**RE: Lot 37 Block 6 Unit 18, S.A.D. 228
Volcano Cliffs Subdivision
6615 Sujeto NW
Grading and Drainage Plan
Rev_GP_for_Pool, 4/8/2022 (D10D003M37)**

Based upon the information provided in your submittal received 4/12/2022, this plan is approved for Revised Grading Permit.

GALLEGOS - GRADING & DRAINAGE PLAN

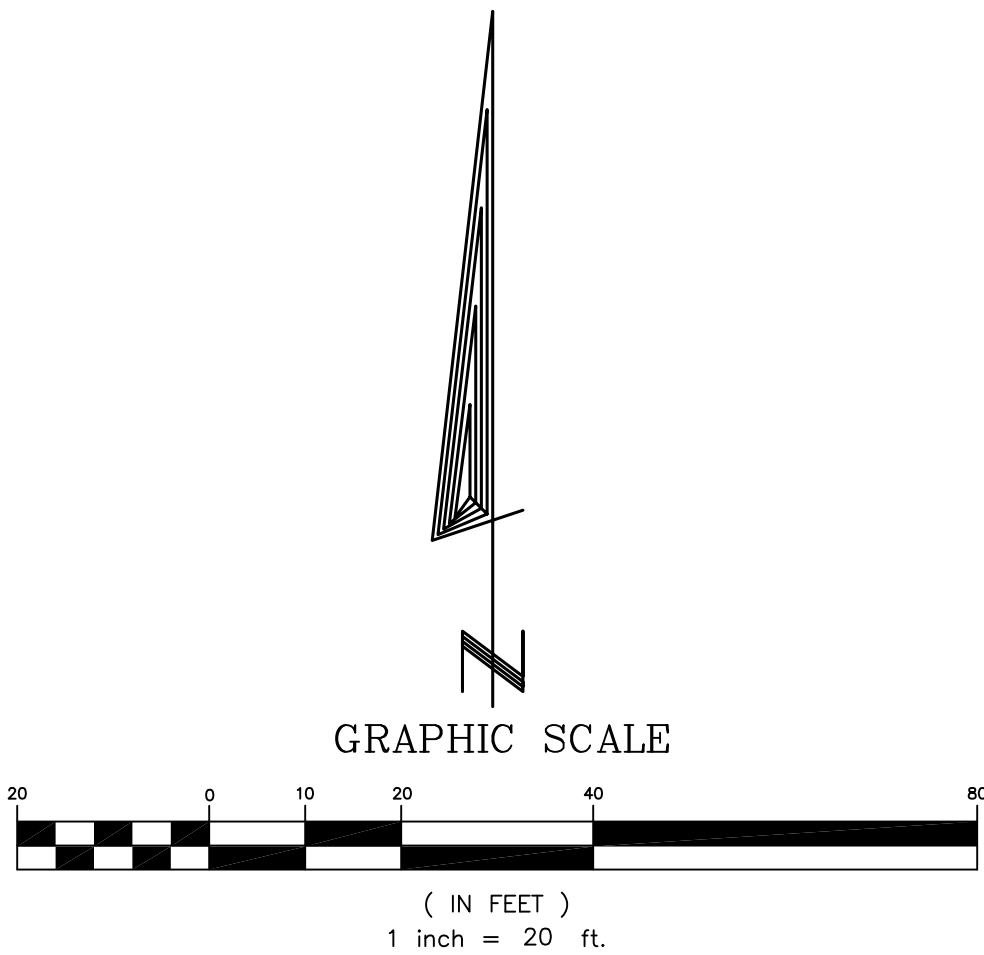
This is the plan to be used for any garden walls and any openings in the walls shall be placed 3" above final grade in the rear yard to allow for cross lot drainage from west to east (upstream to downstream).

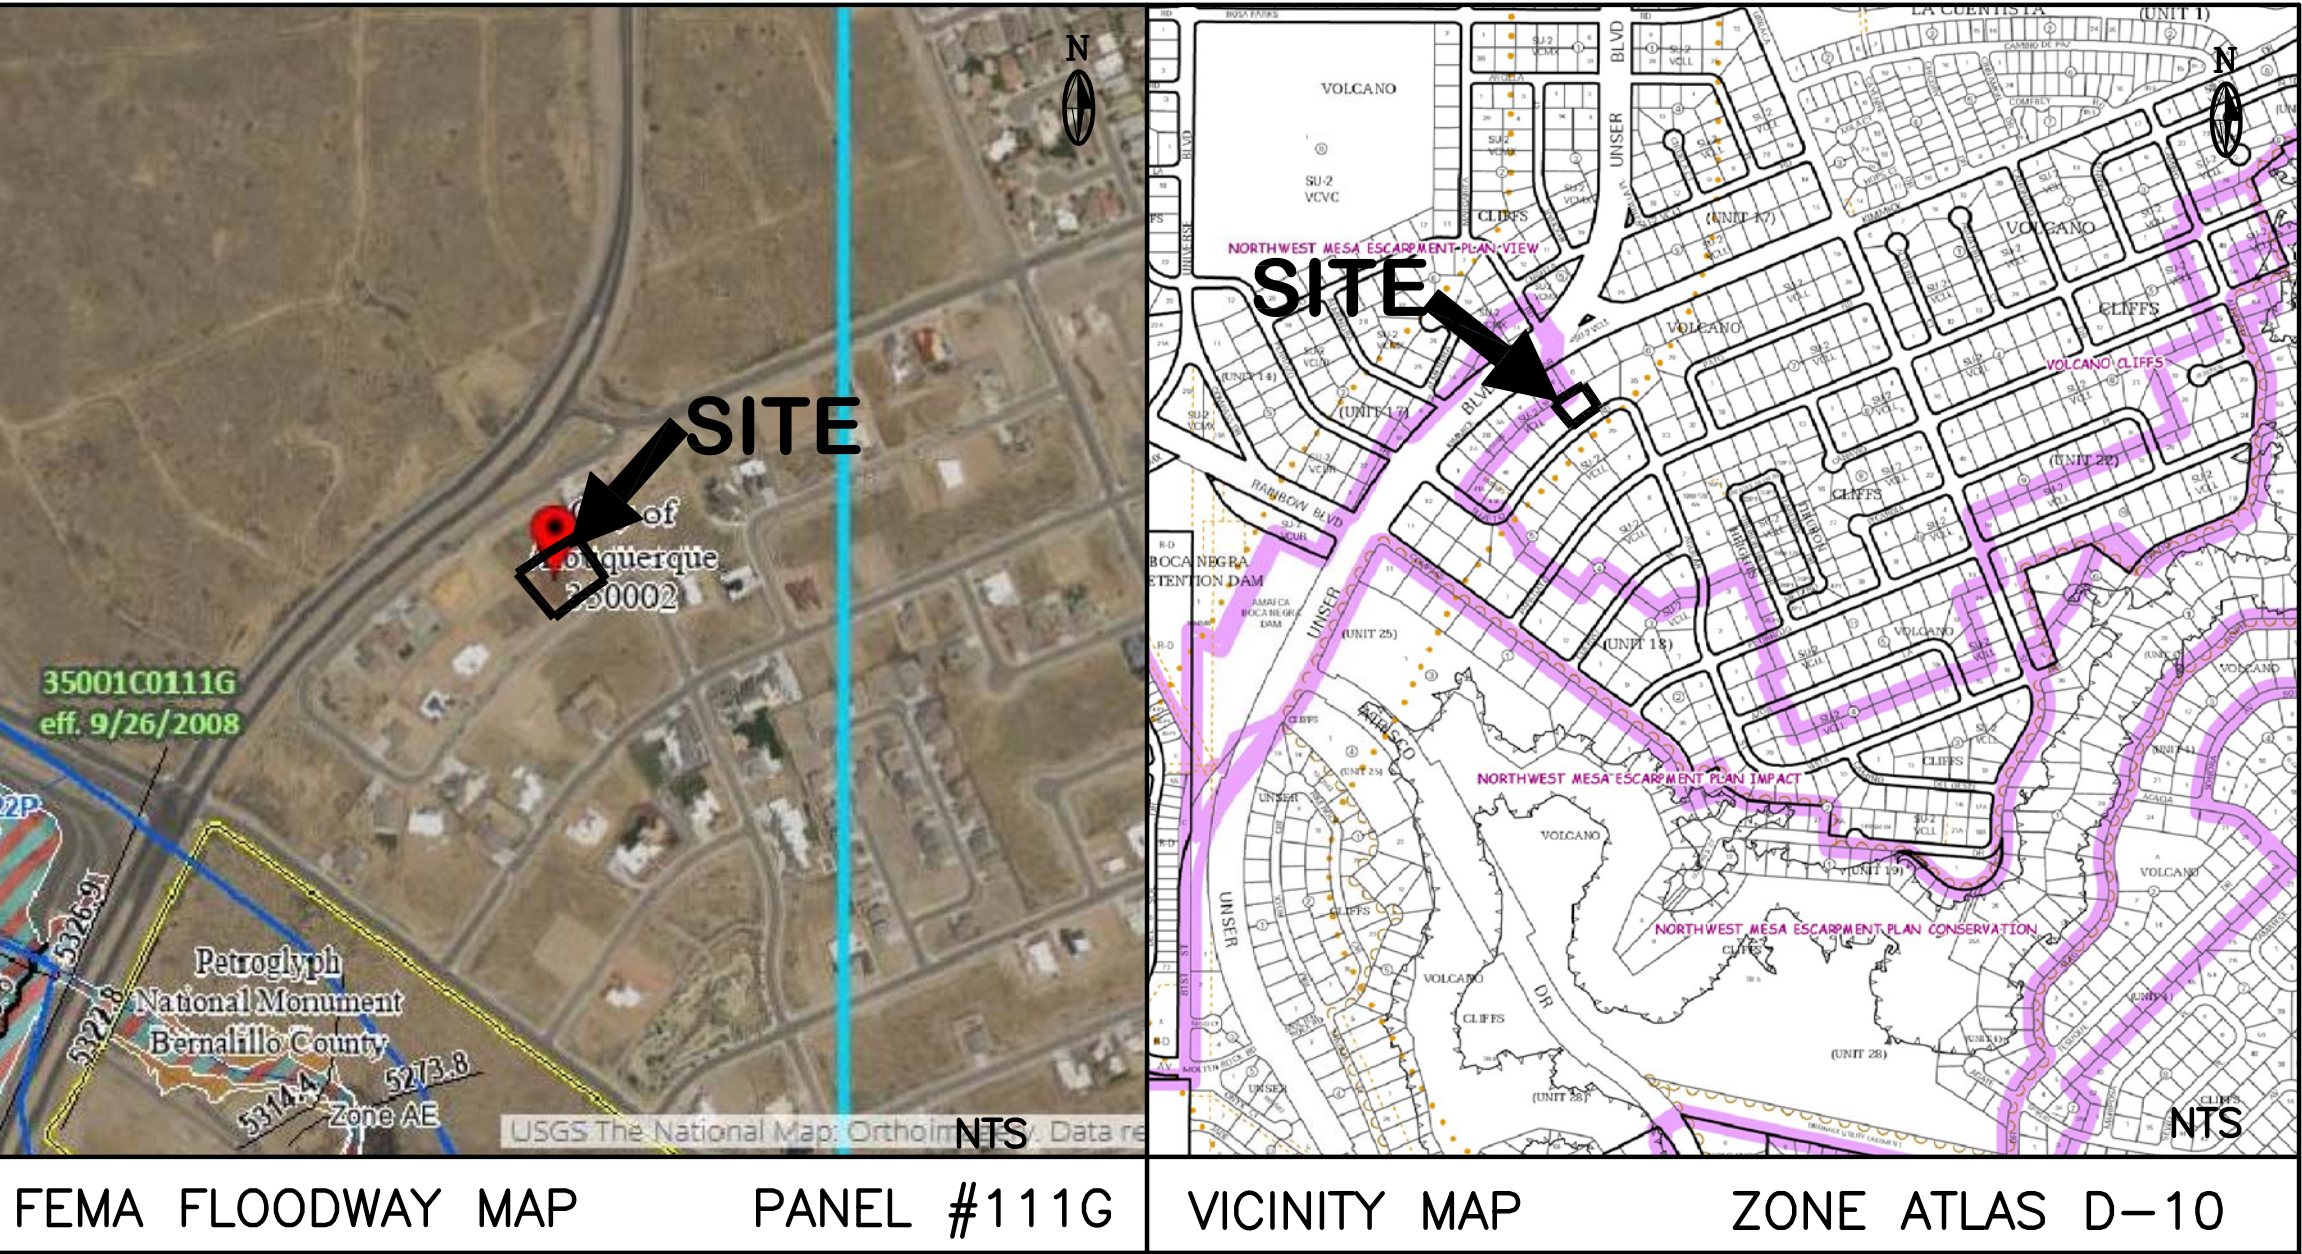
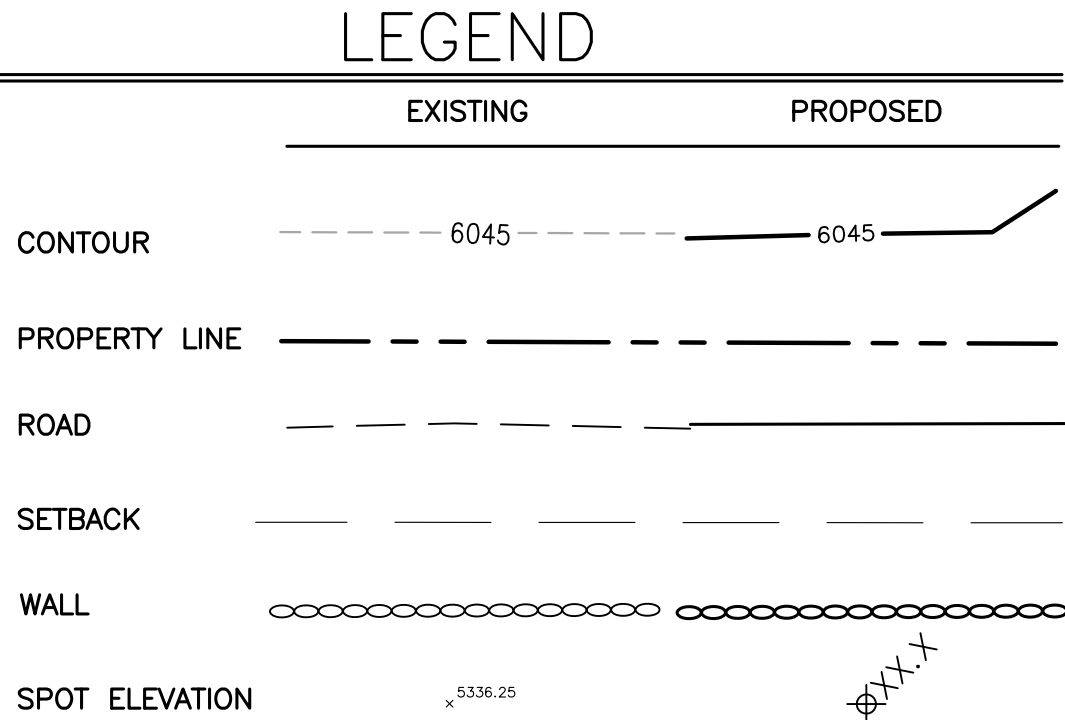
Advise the owner contractor not to use dirt as a ramp to climb the curb, use lumber or crusher fines for this purpose. Place this note on the plan.

Reiterate to the Owner/Contractor that a separate permit for a garden/retaining wall must be obtained with the approved G&D plan and Pad Certification. Also, if a swimming pool is to be placed after this approval a new grading and drainage plan will need to be resubmitted showing the changes for the land treatments.
